Form 3160-5
(June 2019)UNITED STATES
DEPARTMENT OF THE INTERIOR
BUREAU OF LAND MANAGEMENTFORM APPROVED
OMB No. 1004-0137
Expires: October 31, 2021**SUNDRY NOTICES AND REPORTS ON WELLS**
Do not use this form for proposals to drill or to re-enter an abandoned well. Use Form 3160-3 (APD) for such proposals.

8. Well Name and No. FRODERICK 33 FED/506H

Fröderick 33 Fed Com 717H (FKA 506H) API #: 30-025-52154

EOG respectfully requests an amendment to our approved APD for this well to reflect the following changes:

Figure 1: Cameron TA Plug and Offline Adapter Schematic

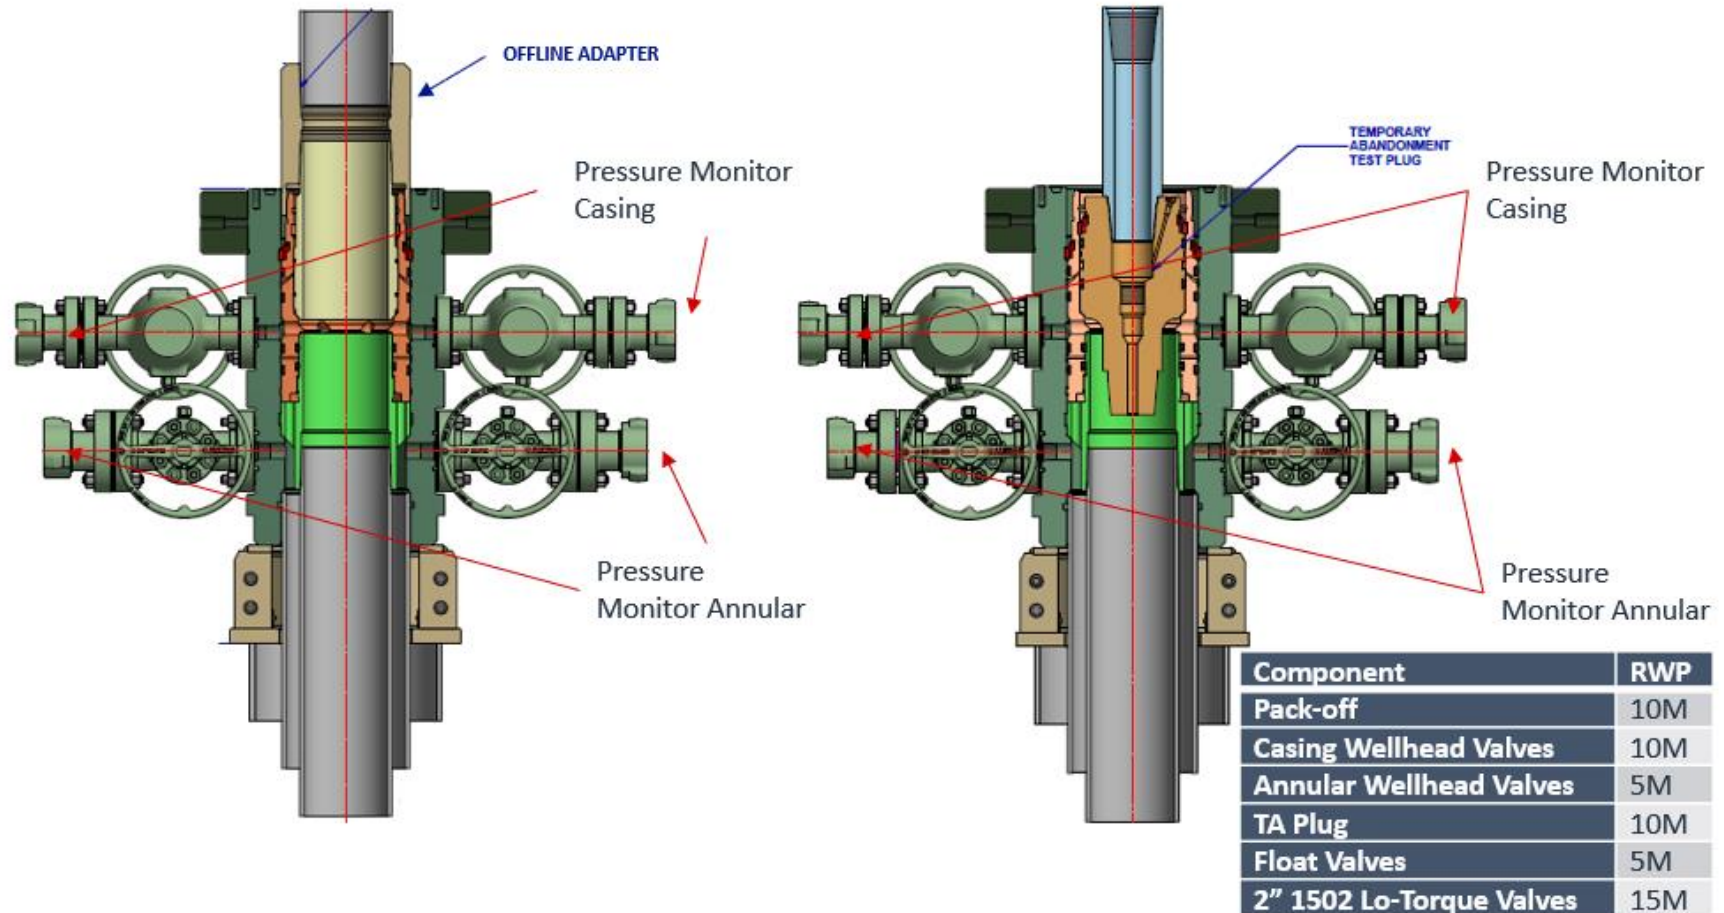
- c. Return line schematics can be seen in Figure 3.
10. Remove TA Plug from the casing.
11. Install offline cement tool.
 - a. Current offline cement tool schematics can be seen in Figure 1 (Cameron) and Figure 2 (Cactus).

Figure 4: Rig Placement Diagram

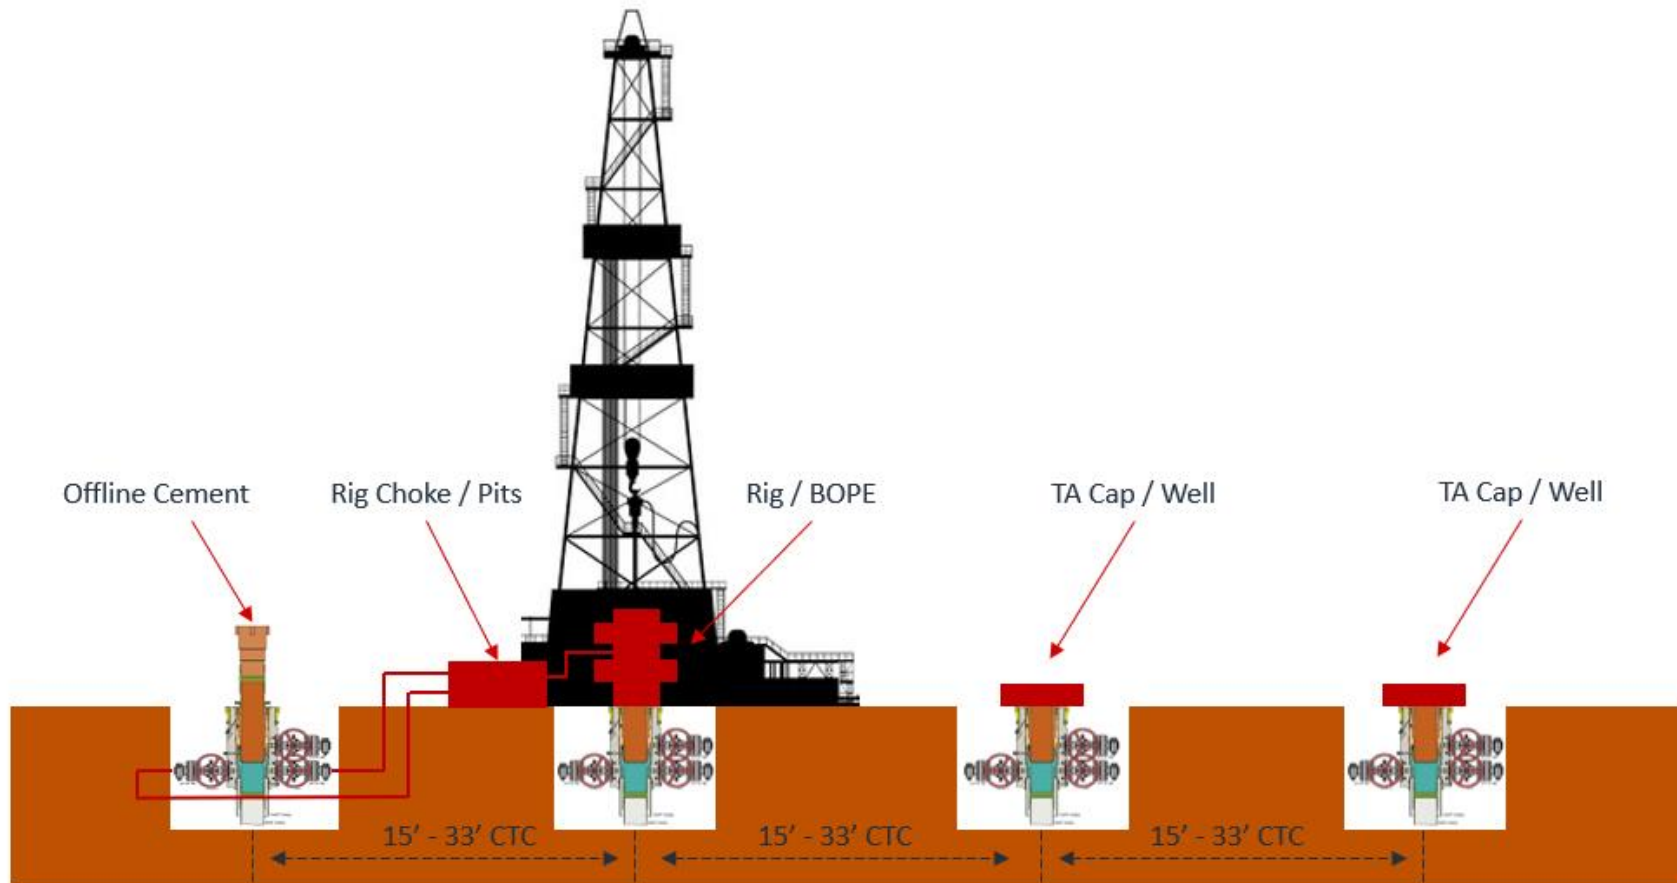
- e. Diagram for rig positioning relative to offline cementing can be seen in Figure 4.
9. Rig up return lines to take returns from wellhead to pits and rig choke.
